XGMII Transmit Direction Timing Clause 46

Velio Communications

January 10-12, 2001

Comments

Source Synchronous Timing

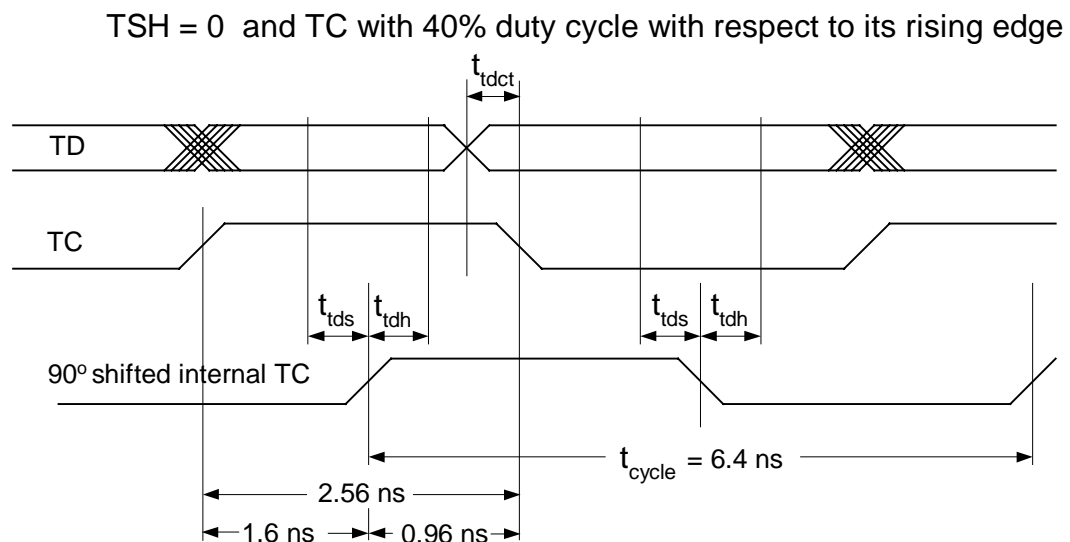
T_{tdct}: Data, Clock Transition Window; T_{tds}, T_{tdh}: setup, hold; 40% Clock Duty Cycle

$$T_{\text{cycle}} * (40\%) - T_{\text{cycle}} * (1/4) > T_{\text{tdh}} + T_{\text{tdct}}$$

$$960 \text{ ps} > T_{\text{tdh}} + T_{\text{tdct}}$$

$$2.56 \text{ ns} - 1.60 \text{ ns} = 0.96 \text{ ns} > t_{\text{tdh}} + t_{\text{tdct}}$$

Source Synchronous Timing

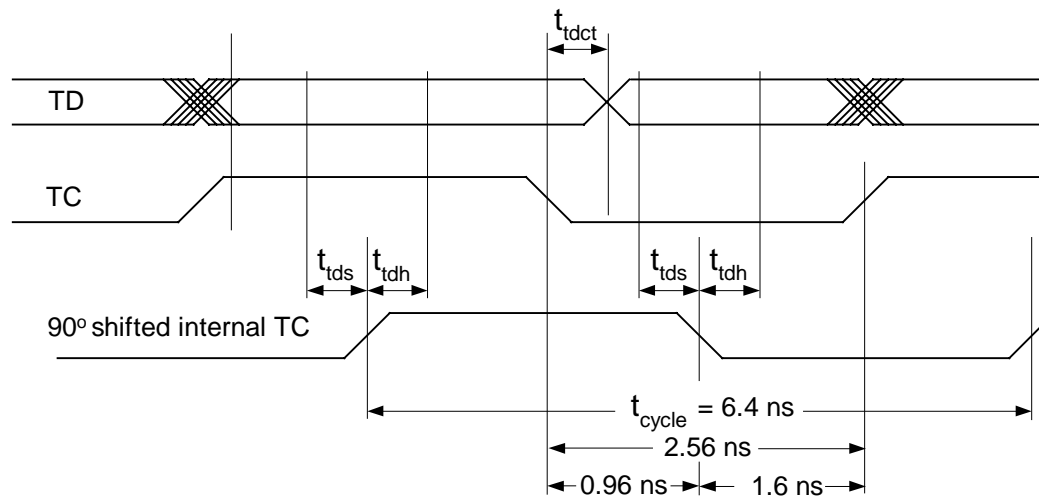
For worse case: TC is 60% duty cycle from its rising edge:

$$T_{\text{cycle}} * (40\%) - T_{\text{cycle}} * (1/4) > T_{\text{tds}} + T_{\text{tdct}}$$

$$960 \text{ ps} > T_{\text{tds}} + T_{\text{tdct}}$$

Adding the two pages: $1920 \text{ ps} > T_{\text{tds}} + T_{\text{tdh}} + 2 * T_{\text{tdct}}$

If $T_{\text{tds}} + T_{\text{tdh}} = 960 \text{ ps}$ at destination, $T_{\text{tdct}} < 480 \text{ ps}$ (from - to + : 960 ps range)

TSH = 0 and TC with 60% duty cycle with respect to its rising edge

$$2.56 \text{ ns} - 1.60 \text{ ns} = 0.96 \text{ ns} > t_{\text{tds}} + t_{\text{tdct}}$$

Setup, Hold Timing

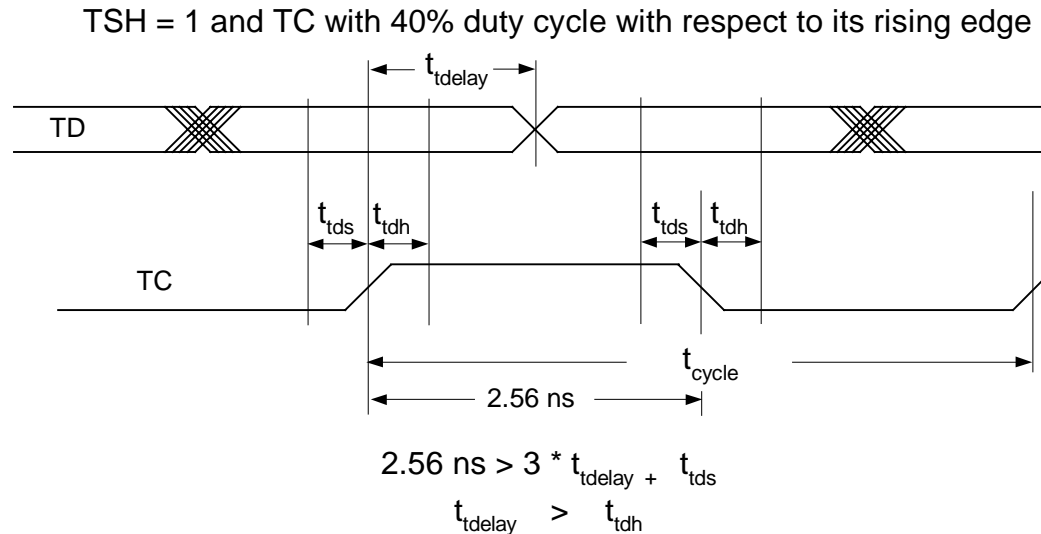
$$T_{\text{cycle}} * (40\%) > T_{\text{tds}} + T_{\text{tdelay(max)}}$$

$$T_{\text{delay(min)}} > T_{\text{tdh}}$$

$$2560 \text{ ps} > T_{\text{tds}} + T_{\text{tdelay(max)}}$$

$$2560 \text{ ps} - (T_{\text{tds}} + T_{\text{tdh}}) > T_{\text{tdelay(max)}} - T_{\text{tdelay(min)}}$$

If $T_{\text{tds}} + T_{\text{tdh}} = 960 \text{ ps}$ at destination

$$1600 \text{ ps} > T_{\text{tdelay(max)}} - T_{\text{tdelay(min)}}$$

If T_{tdh} is 480 ps, T_{delay} range is: 480 – 2080 ps at destination (at driver: 960 – 1600)

If T_{tdh} is 160 ps, T_{delay} range is: 160 – 1760 ps at destination (at driver: 640 – 1280)

The first case gives a $T_{\text{delay(max)}} / T_{\text{delay(min)}}$ ratio of 1.67, the second: 2.00

- Setup and Hold Timing is Better than Source Synchronous
- Asymmetry in Setup and Hold more flexible for the ASIC/FPGA
-

Recommend		Old	
	Driver	Receiver	Driver	Receiver
Tsetup	1280ps	800ps	960	480
Thold	640ps	160ps	960	480
